Steven M. Snider
Vice President
Oconee Nuclear Station

RA-22-0036
February 14, 2022

Subject: Duke Energy Carolinas, LLC (Duke Energy)
Oconee Nuclear Station (ONS), Units 1, 2, and 3
Docket Numbers 50-269, 50-270, 50-287
Renewed License Numbers DPR-38, DPR-47, DPR-55
Subsequent License Renewal Application
Responses to NRC Request for Additional Information Set 2

Figure 3.5.2.2.1.6-1 – Fuel Transfer Tube Penetration

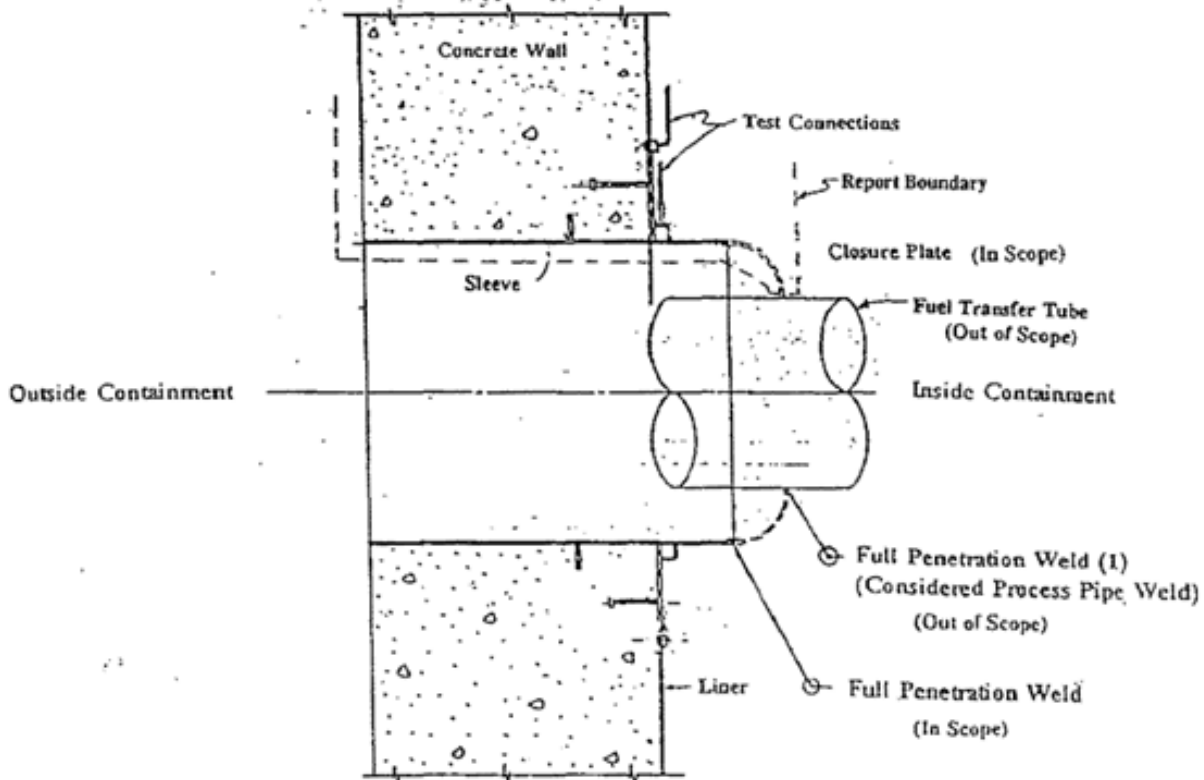
Regarding the stainless steel fuel transfer tube and how it is connected to the containment liner in order to establish an essentially leak-tight barrier is represented in Figure 3.5.2.2.1.6-1. As shown in the figure, the closure between the transfer tube and the sleeve that is integrally welded to the containment liner consists of a carbon steel circular plate that is shop welded to the stainless steel fuel transfer tube and a short segment of carbon steel pipe to mate with the sleeve. In this case, the carbon-to-stainless steel weld is at the surface of the stainless tube. The design code jurisdictional boundary places ownership of the carbon to stainless steel weld with the fuel transfer tube. The fuel transfer tubes are evaluated with the spent fuel cooling system in ONS SLRA Section 2.4.2 with SCC addressed in ONS SLRA Table 3.3.2-17, Auxiliary Systems - Spent Fuel Cooling System - Aging Management Evaluation. Each unit has two fuel transfer tube penetrations.

Figure 3.5.2.2.2.6-1-1
 RV support assembly IWF-2500 examination boundary A-D-E-F-G-C-B. (Reference: Relief Request RR 15-ON-004)

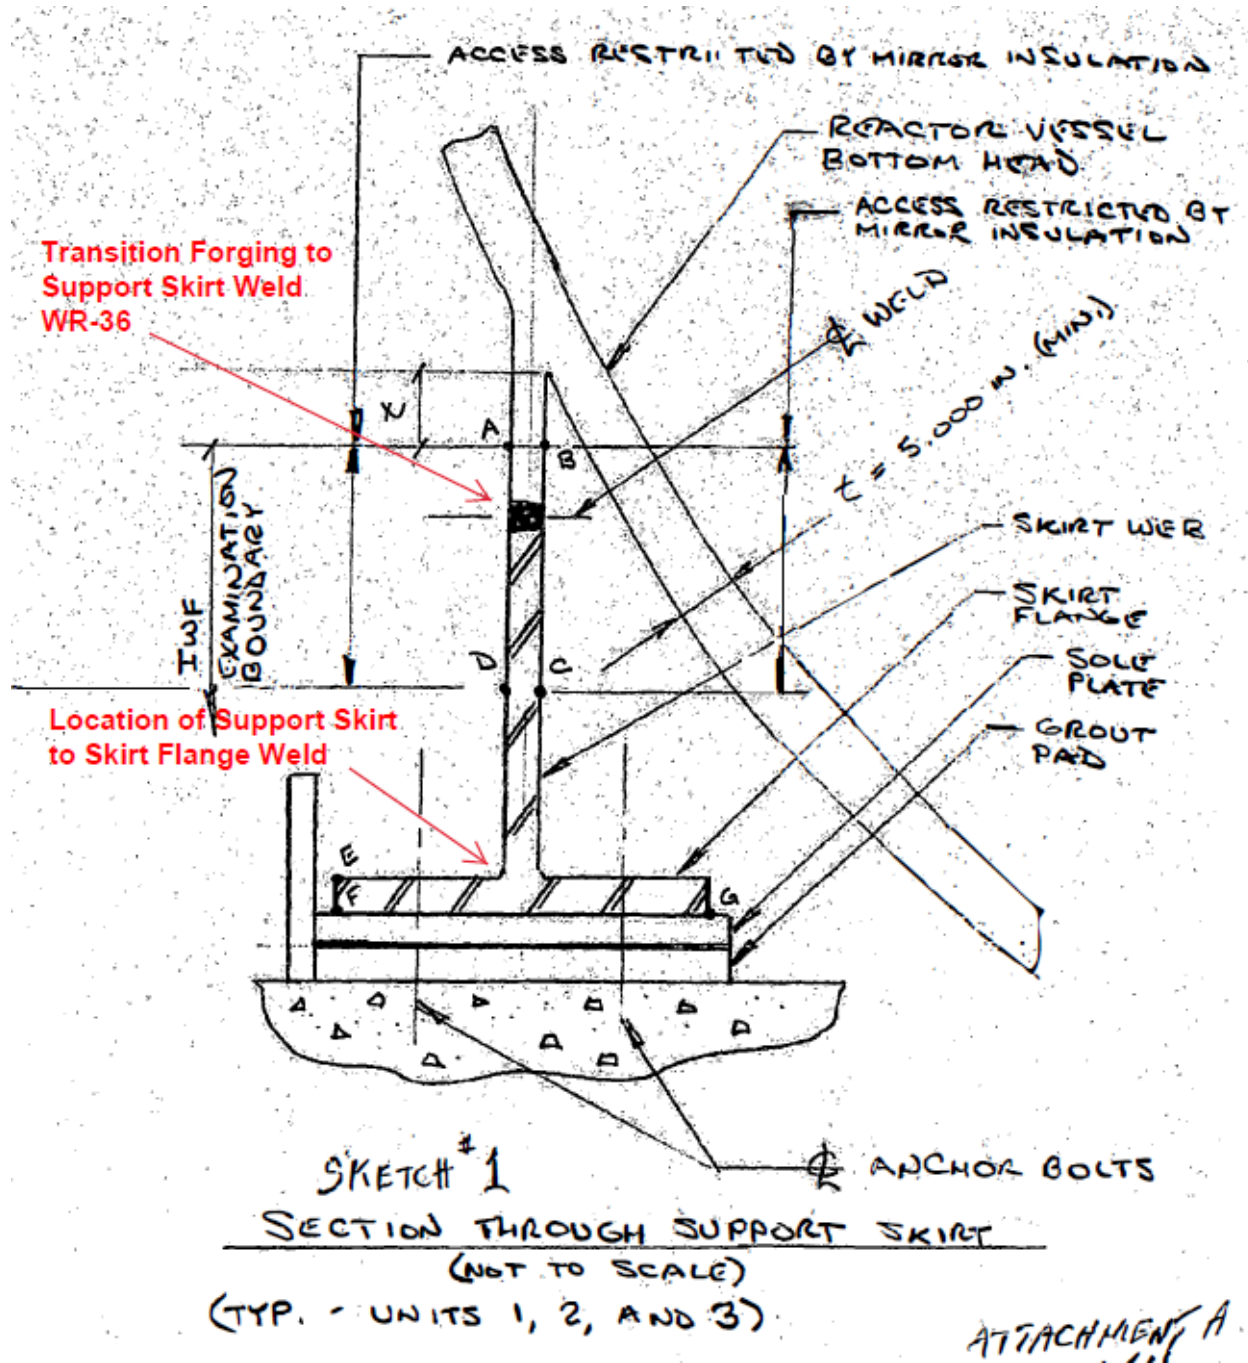
- b. The baseline condition of weld WR-36 has been established in part through the absence of bounding degradation detected on the horizontal surface of the RV support assembly for Oconee Units 1, 2, and 3. Figure 3.5.2.2.2.6-1-1 shows that the IWF-2500 examination boundary for the RV support assembly consists of vertically-oriented and horizontally-oriented regions. Weld WR-36 is located in the upper part of the assembly vertical region. The assembly horizontal region consists of the support flange, the support skirt to support flange weld, and the anchor bolts. RR 15-ON-004 described that while a limited portion of the accessible examination surface is comprised of surface A-D, which includes weld WR-36, most of the accessible examination surface is comprised of surfaces D-E and G-C, which are situated at a lower elevation than weld WR-36, and include the horizontally-oriented skirt flange, support skirt to skirt flange weld, and the anchor bolts. It is reasonable to expect that the horizontally-oriented regions of the RV support flange would develop degradation (i.e., loss of material) more readily than the vertically-oriented regions of the support skirt, since the horizontal surfaces are more likely to be potentially exposed to standing water or accumulate boron deposits. Any degradation detected on the horizontal regions of the RV support assembly, where examination accessibility is greater, would precede, or bound, degradation that may develop on vertical regions of the support skirt including weld WR-36. In addition, ANP-3898NP Section 9.4.5 reports that since weld WR-36 is not impacted by irradiation embrittlement over an 80-year operating life, reduction in fracture toughness due to irradiation embrittlement is not a concern.
